**CITY OF VANCOUVER
DEVELOPMENT, BUILDINGS, & LICENSING**

**DEVELOPMENT PERMIT STAFF COMMITTEE
MEETING
January 31, 2024**

**989 West 41st Ave – Parcel C (COMPLETE APPLICATION)
DP-2023-00755 – CD-1 (Pending)**

Figure 3: Parcel C Massing Redistribution

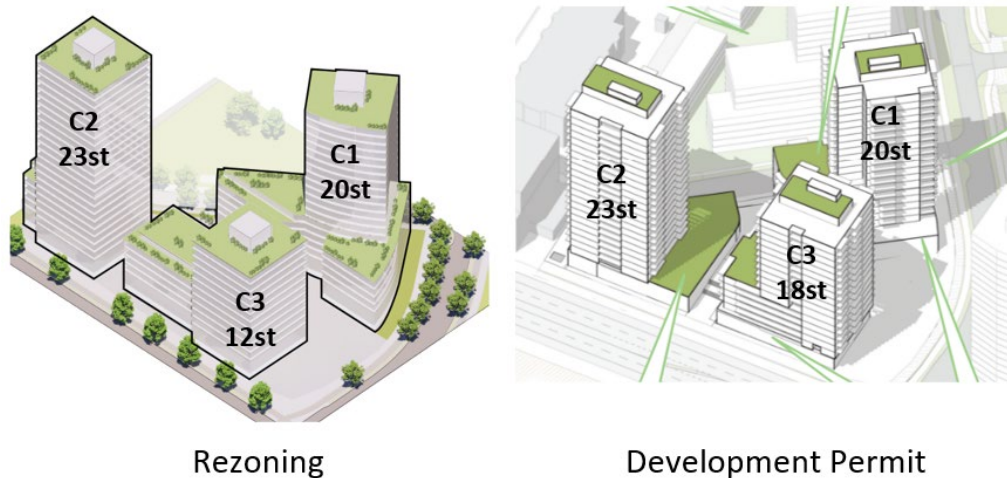
A minor variation in building height and massing from the rezoning is proposed. The *Guidelines* envision three towers of distinct heights for Parcel C (Figure 2): a 20-storey tower on a six-storey podium (C1); a 23-storey tower on a six-storey podium (C2); and a 12-storey tower on a six-storey podium (C3). An increase in the height of tower C3 from 12 to 18 storeys is proposed due to the following considerations (Figure 3):

- a) consolidation of all market rental units into one building (C-3)
- b) the relocation of the transformer from below grade on Parcel D (east) to above grade on Parcel B (north) for technical and safety requirements by BC Hydro and Translink. Some floor area was relocated to create a setback along the west to allow for below-grade service connections between 41st Ave and Parcel B.
- c) The podium for C2 was lowered to one storey to enhance solar access to the mews and reduce impact on the passage between C2 and C3.

The proposed height and massing changes provide three distinct building heights and generally meet the *CD-1 By-law* and the intent of the *Guidelines*. The height increase does not add shadowing on the new park. The application generally reflects the intent of the *Guidelines*, except as noted in the recommended conditions of approval.
